WICHITA-SEDGWICK COUNTY
METROPOLITAN AREA PLANNING COMMISSION

April 26, 1990

STAFF REPORT

CASE NUMBER: S/D 90-13 - EAST SUBSTATION ADDITION

EAST SUBSTATION ADDITION

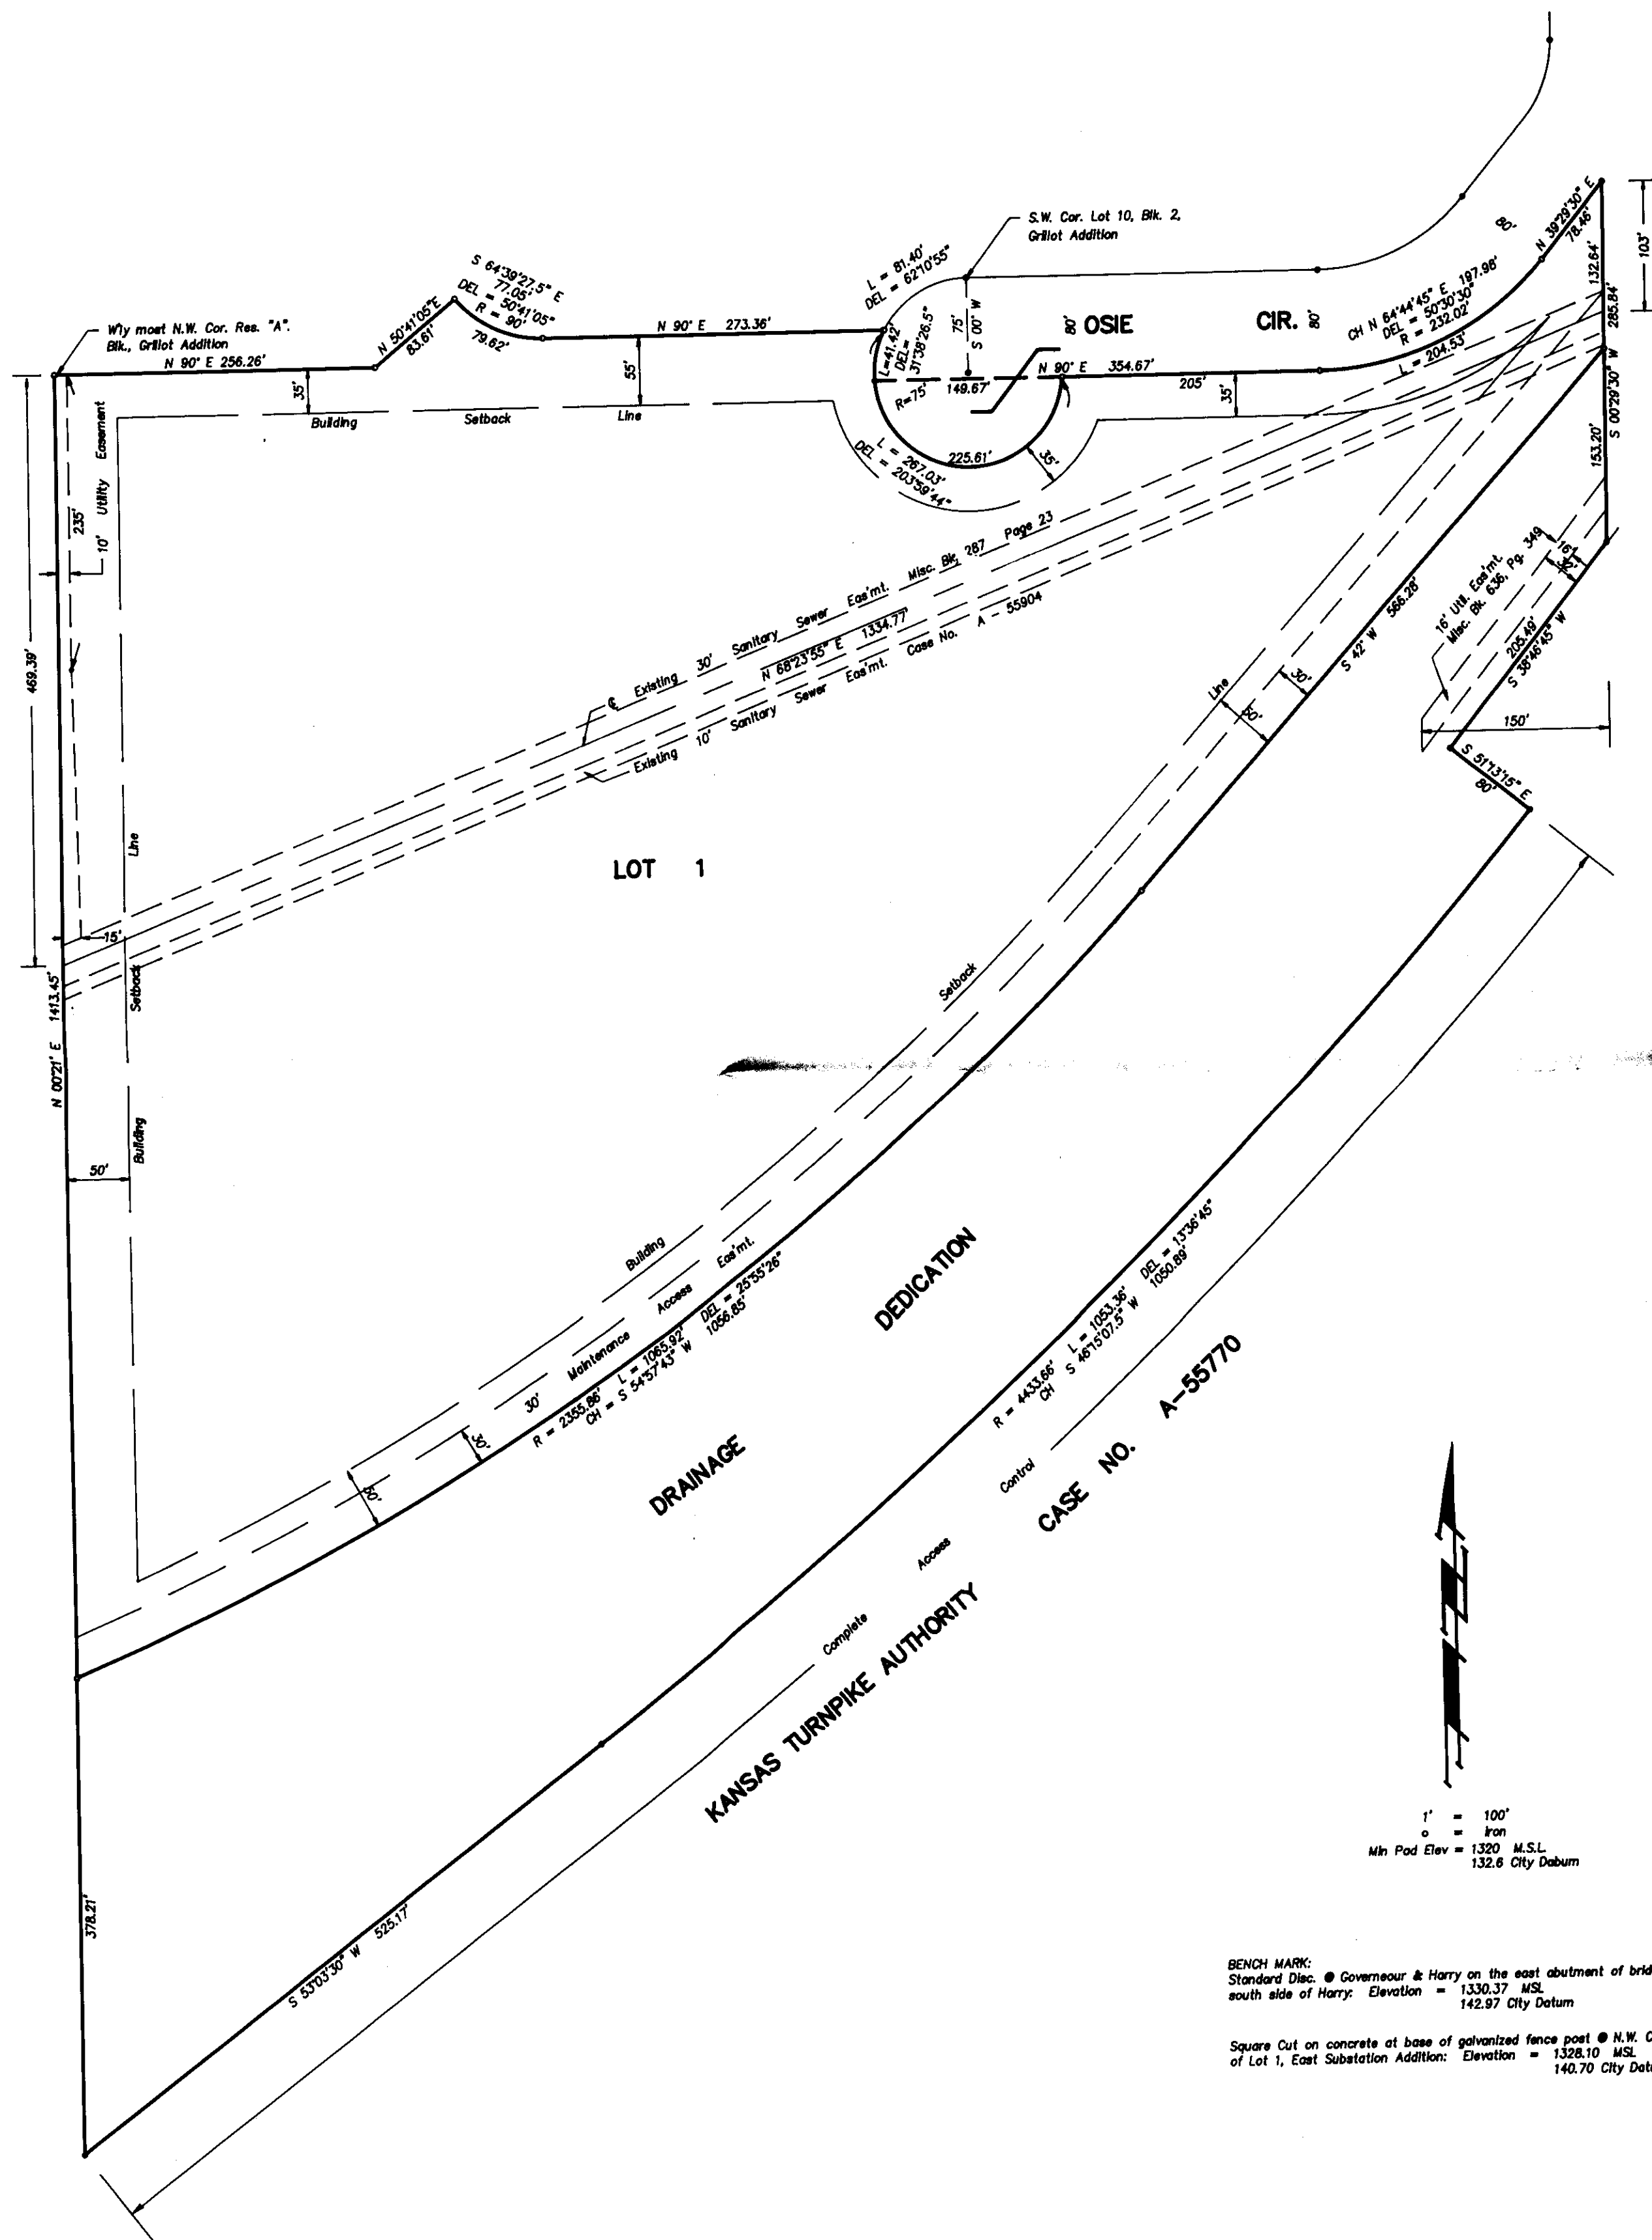
- J. Perimeter closure computations shall be submitted with the final plat tracing. Section 5-101(c).
- K. Recording of the plat within 30 days after approval by the City Council.

- A. The applicant shall provide for any drainage improvements required by the platting of this property. These guarantees may be included with the paving guarantees.

- B. The applicant shall provide for the paving of the interior street (Osie/Gouverneur from Harry) and the cul-de-sac required for the proper termination of Osie Circle.

- D. Since this plat is proposing the vacation of a portion of the south half of Osie, abutting property owners to the north should also consent in the vacation. The applicant shall therefore attempt to get the owners of Lot 1, Grillot 3rd and lots 11 and 12, Grillot Addition to sign a separate vacation application for the north half of Osie. As part of the vacation, the owner of Lot 12, who is also the owner of Lot 2, Grillot Addition should be required to submit a covenant requiring that these two lots not be sold separately. The covenant is necessary since Lot 12 will no longer have access to a public street. If such a covenant cannot be obtained the City by separate instrument should establish an access easement to the benefit of Lot 12, Grillot Addition which would allow access to Osie Circle.

- E. Since the tie point for this plat is referenced to a previously platted lot corner, the engineer's text shall reference the quarter section in which the plat is located. Section 5-402(D)(3).

- F. The applicant shall submit an avigational easement covering all of subject plat and a restrictive covenant assuring that adequate construction methods will be used to minimize the effects of noise pollution in the habitable structures constructed on subject property.

- G. The final plat tracing shall indicate utility easements for the planned storm water sewer and existing sanitary sewer along this plat's east line. Also, the plat tracing shall indicate the utility easements requested by Southwestern Bell Telephone and indicated on the enclosed marked copy of the plat.

- I. The applicant's engineer is advised that the Register of Deeds is requiring the name(s) of the notary public, who acknowledges the signatures on this plat, to be printed beneath the notary's signature.
